*Proceedings of the Madras Government, Public Works Department,
1st July 1873.*

Report to accompany the
~~Revised~~
~~Supplemental~~ Estimate of the cost of making
certain alterations to the Royal Artillery
Guard Room. —

Revised Estimate for
converting a portion
of guard room into
a harness room for
the Royal Artillery,
Bristol.

Plan of a portion of
the Artillery-Guard
Room, showing the po-
sition of saddle racks
to be fixed.

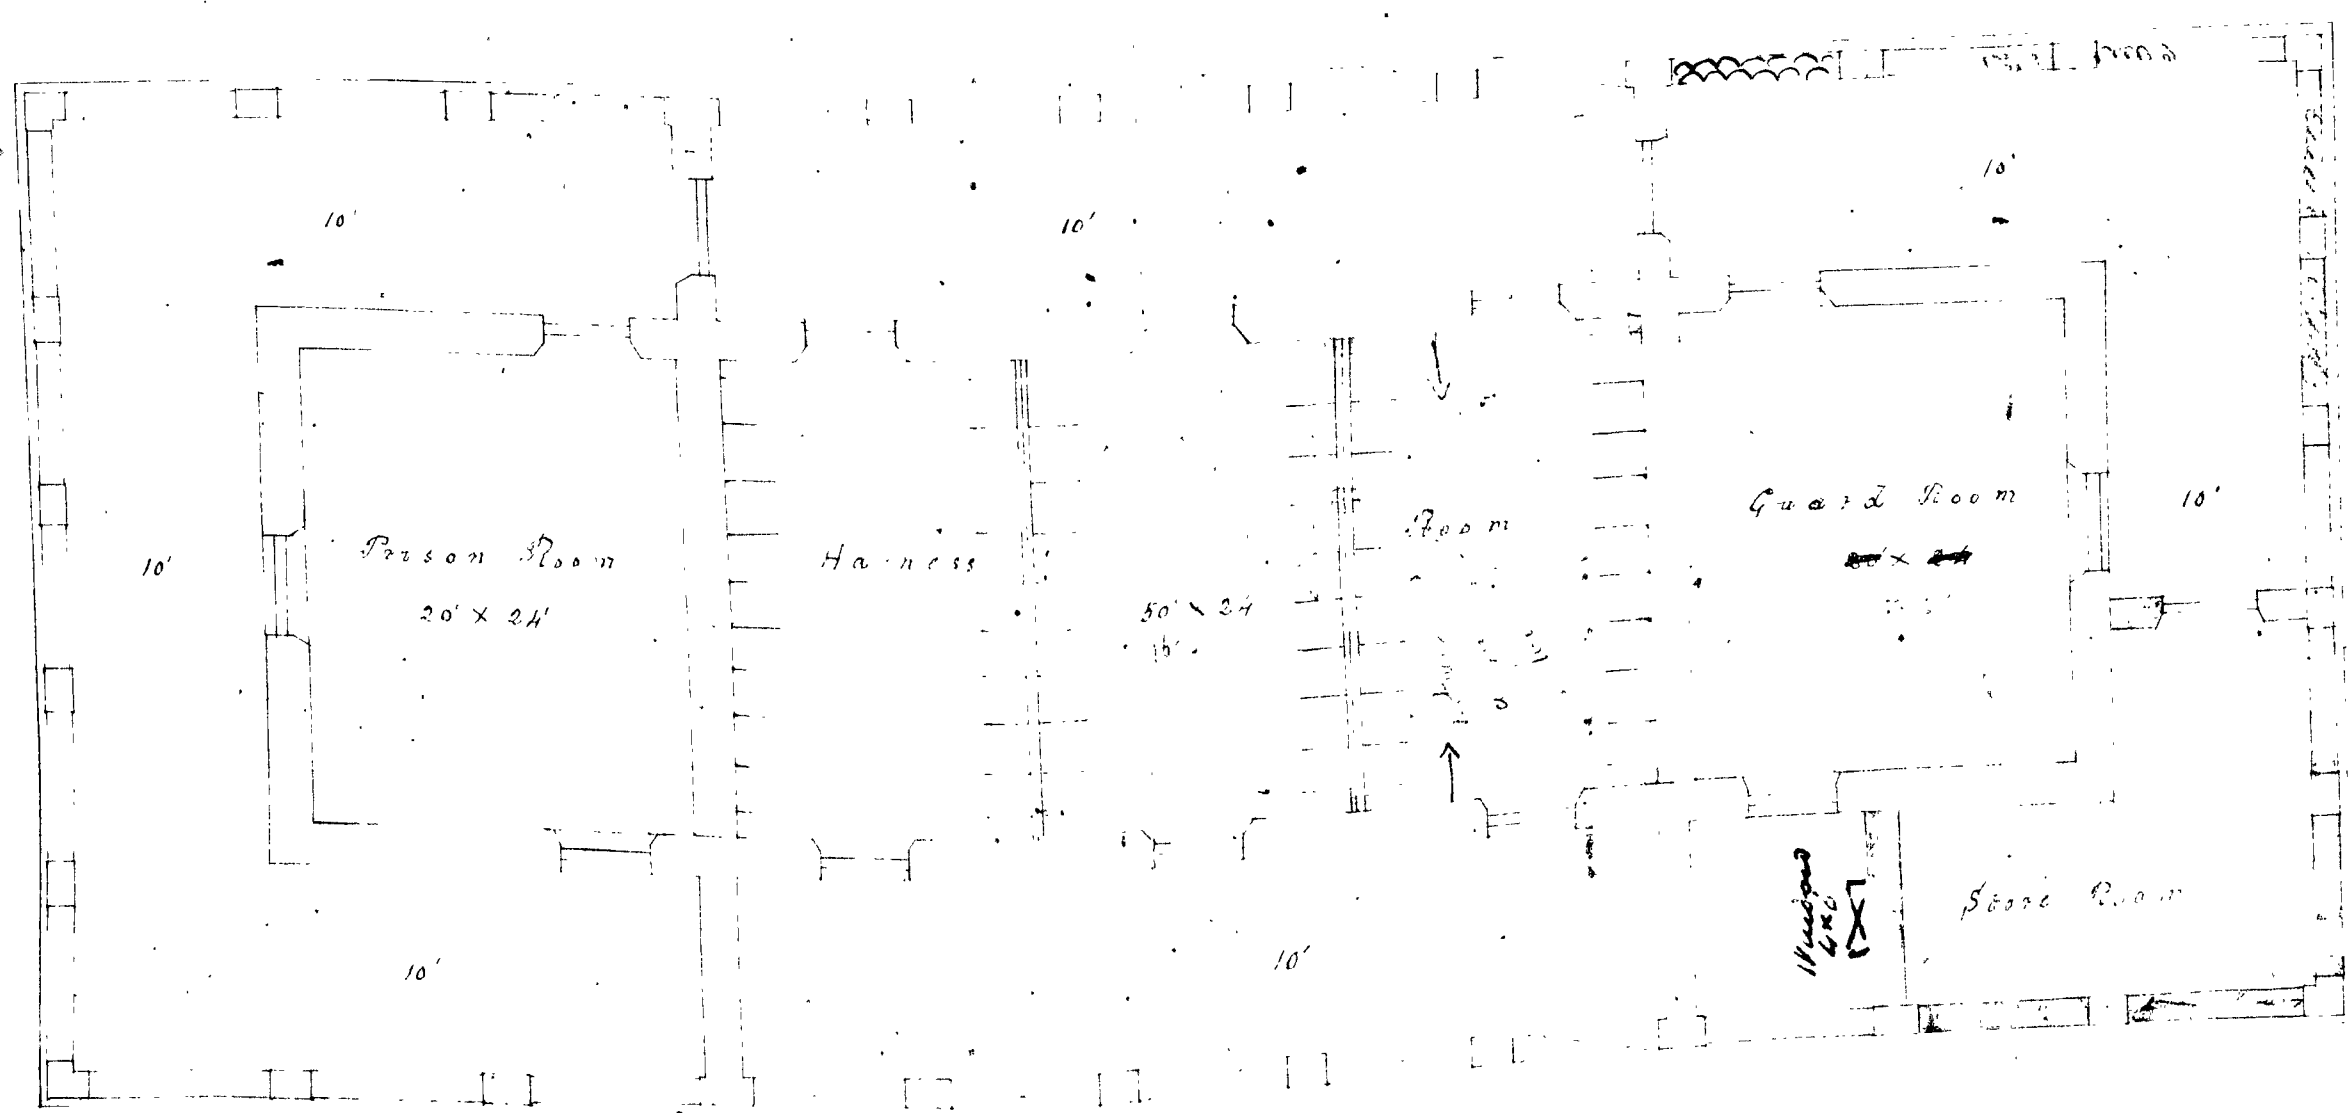
3. It will be observed from the sketch marked A. that the error arose in providing for projections from the upper horizontal bar alone, instead of from both upper and lower horizontal bars.

In the former Estimate provision
was made for supplying stands for
60 sets of horses only, whereas stands
for 120 sets are required. This mistake oc-
curred through having in the first Es-
timate forgotten to allow for braces on
the lower horizontal supports. —

In the revised Estimate a portable
stand for two sets of double horses
has been provided for. It was at
first intended to fix pegs in the wall
for these, but as the pegs would never
be firm, it is now proposed to build
a separate stand. The Officer

Plan

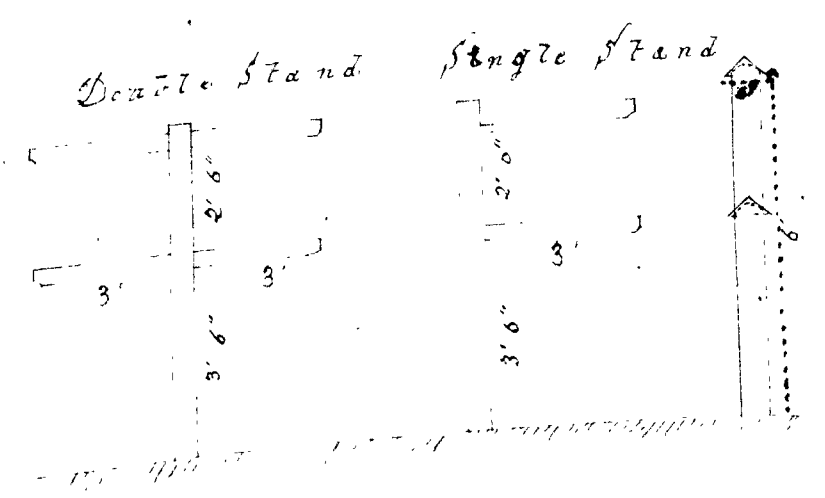
Fire work to be removed

New Masonry Required
